EASTERN CONNECTICUT
ENVIRONMENTAL
REVIEW TEAM
REPORT

ASHFORD ESTATES SUBDIVISION ASHFORD, CONNECTICUT

REVIEW DATE: JANUARY 17, 1989

ASHFORD ESTATES ASHFORD, CONNECTICUT

WATERSHED BOUNDARY

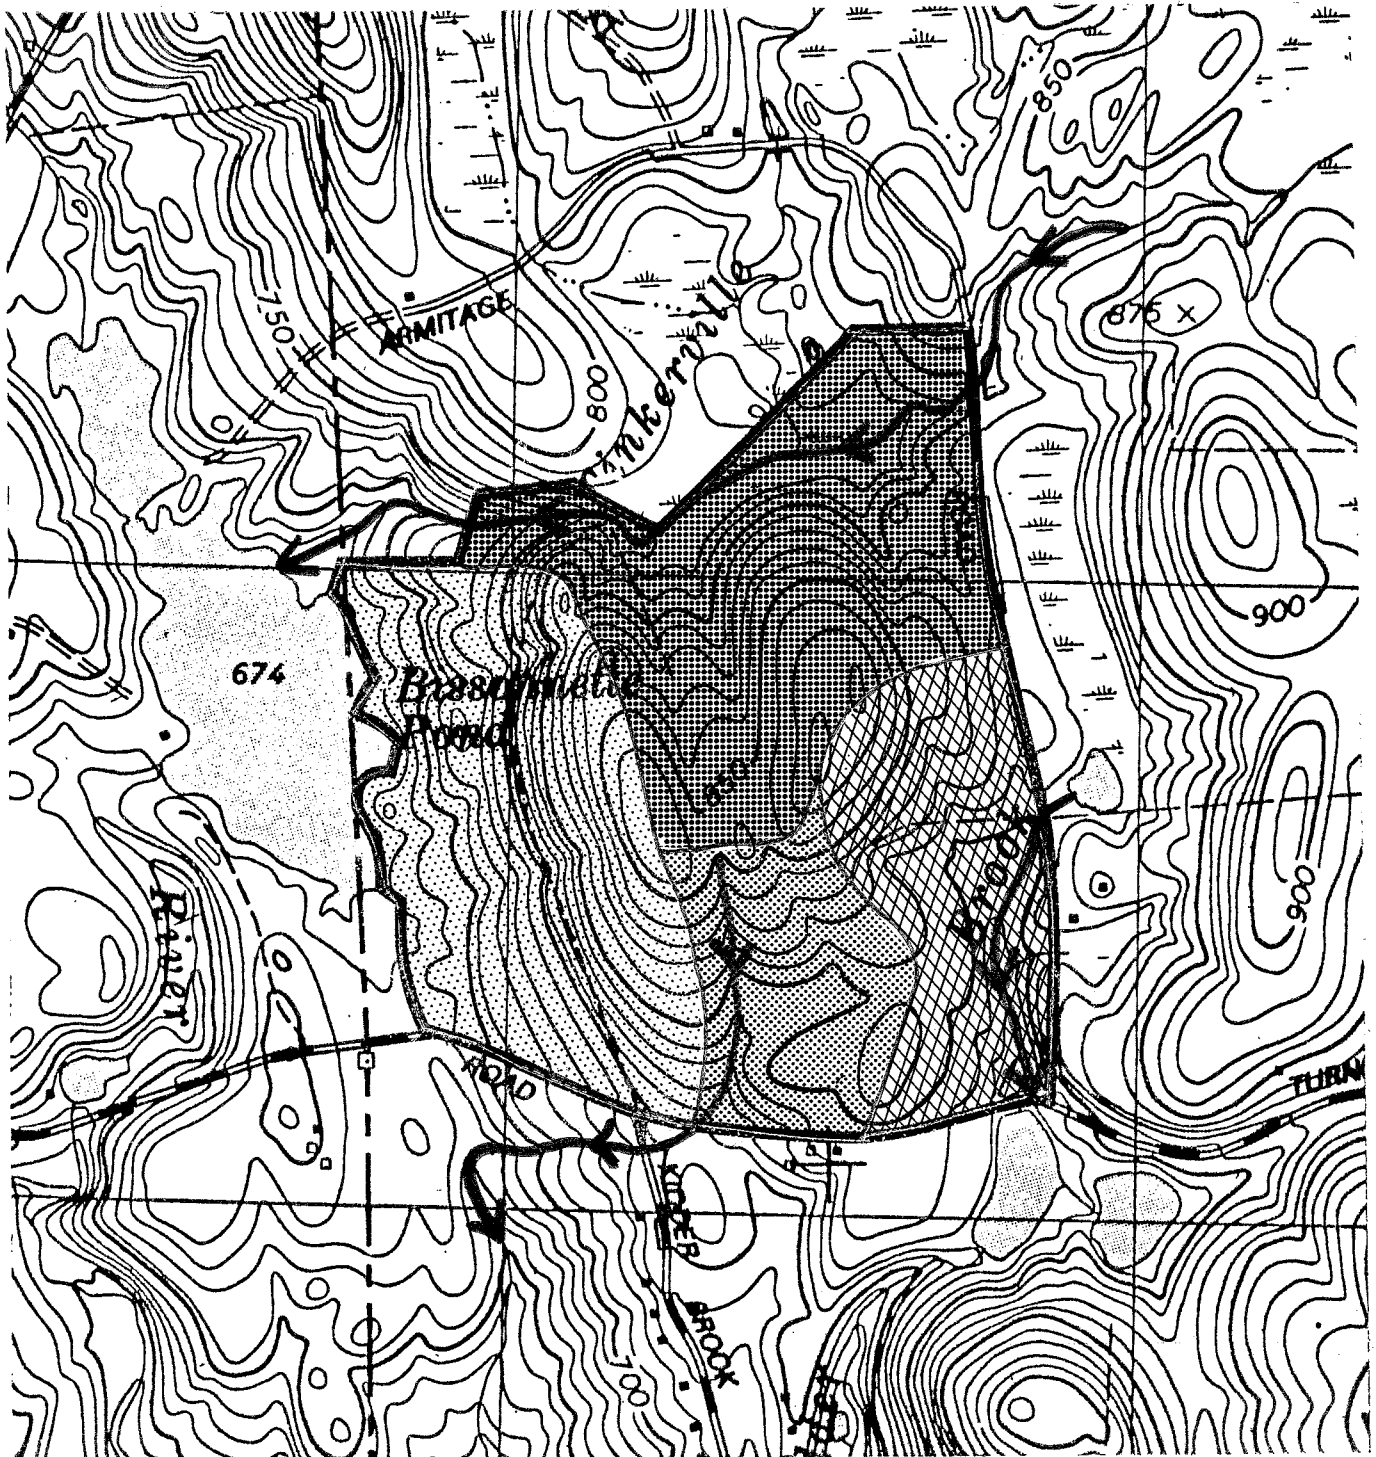
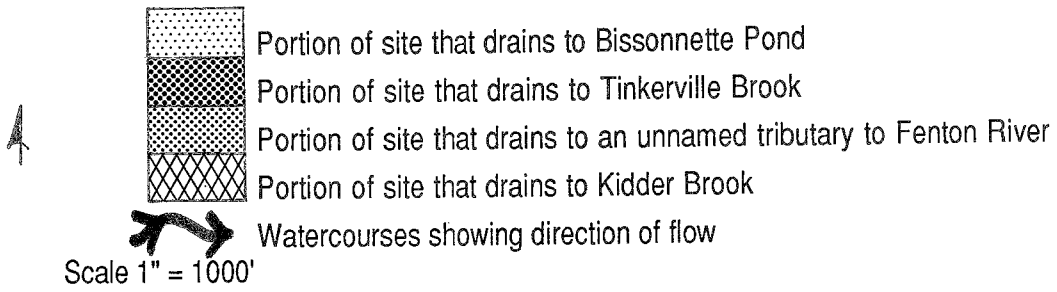
In order to properly assess post-development runoff in the study area , the developer should be required to prepare a stormwater management plan. The plan would include all pre- and post -development runoff calculations. It is recommended that Connecticut's Guidelines for Erosion and Sediment Control be closely followed with regard to stormwater management on the site. The management plan and calculations should be carefully reviewed by the Town's engineer and other appropriate town officials. The impacts of post-development runoff in the study area should be clearly understood in terms of flooding and streambank erosion. It is recommended that a written report accompany the plan which states the initial conditions and storm frequencies to be analyzed. A summary table showing the pre-development , post- development and designed system peak discharges for all design frequencies should also be included. An examination of all downstream culverts is warranted.

Every effort should be made to protect the streamcourses and surface water bodies on and off the site. This will help to minimize the chances for siltation problems. It seems likely that in order to protect the surface water bodies on the site, temporary and/or permanent sediment basin(s) will be required during the construction phases, especially in the areas of moderate to steep slopes and the presence of silty soils. These basins, as well as catch basins and roads, will

VEGETATION

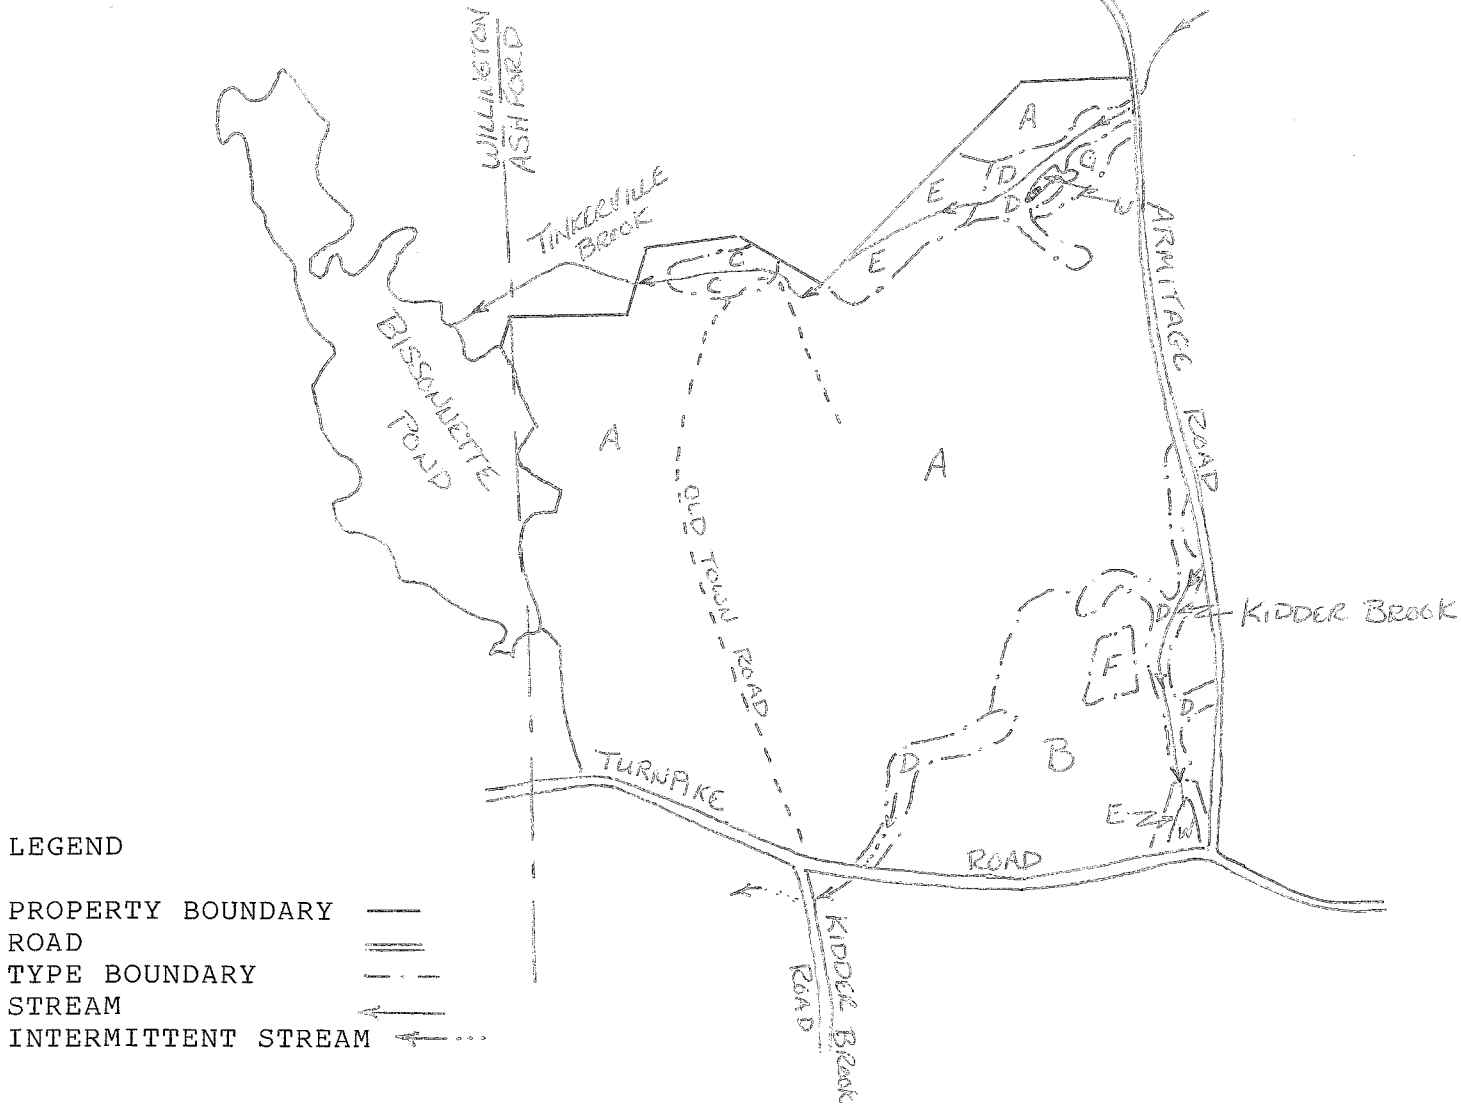
Vegetation Type A would benefit from a light thinning to reduce the overstocked condition and improve the overall health and vigor of the stand. The undesirable growing stock of the pole and sawtimber classes should be removed. An effort should be made to retain the desirable large diameter black birch as well as scattered softwoods, not only for their high aesthetic value but also to maintain the diversity of the species.

Due to the light volume per acre to be removed (3 cords and 500 board feet) in **Type A**, it would be best to combine the thinning operation with the road and houselot clearing operations. Removal of the culls, which because of their location may be hazardous, may contribute some fuelwood volume.

Eventually **Vegetation Types F and G** will become fully stocked with trees as forest succession proceeds. Reinforcement planting could be undertaken if desired after development is complete. Suitable species for this site would be white pine, hemlock or Norway spruce.

HISTORIC PRESERVATION

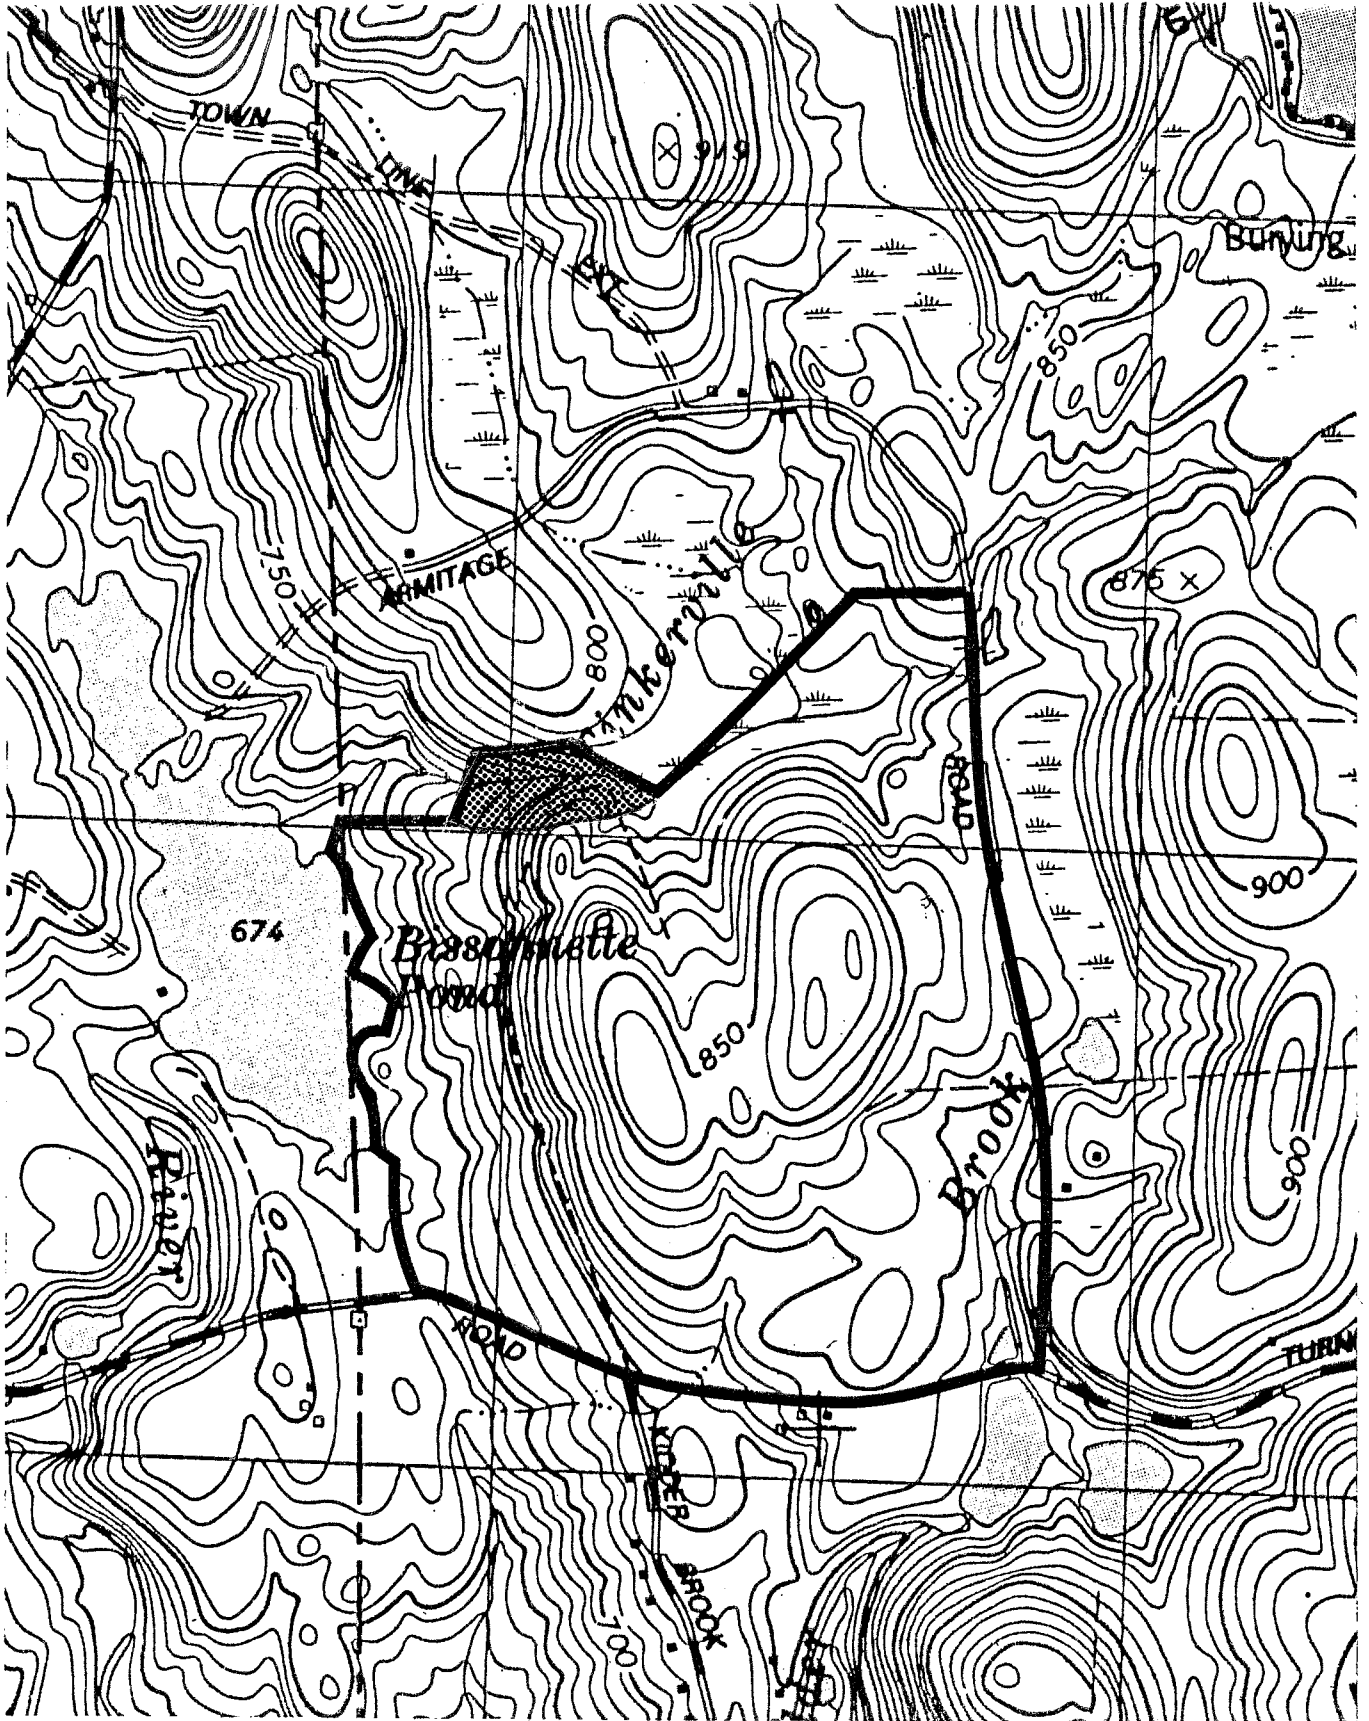
A professional archaeological reconnaissance survey is strongly recommended in order to locate and identify all prehistoric and historic resources which might exist in the project area. In addition, an historic preservation easement should be considered to protect the mill complex from being adversely effected by future land use decisions. These cultural resources are significant to the historic heritage of the people of Ashford and eastern Connecticut and deserve the enforcement of preservational guidelines.

In summary, the project area is located in a critical area of importance to the early industrial history of the Town of Ashford. Two large early-to-mid 19th century mill sites and adjacent structures were located along Tinkerville Brook. It is strongly recommended that all feasible efforts be undertaken to identify and ensure the preservation and conservation of the cultural resources in the area, including the establishment of historic preservation easements along Tinkerville Brook.
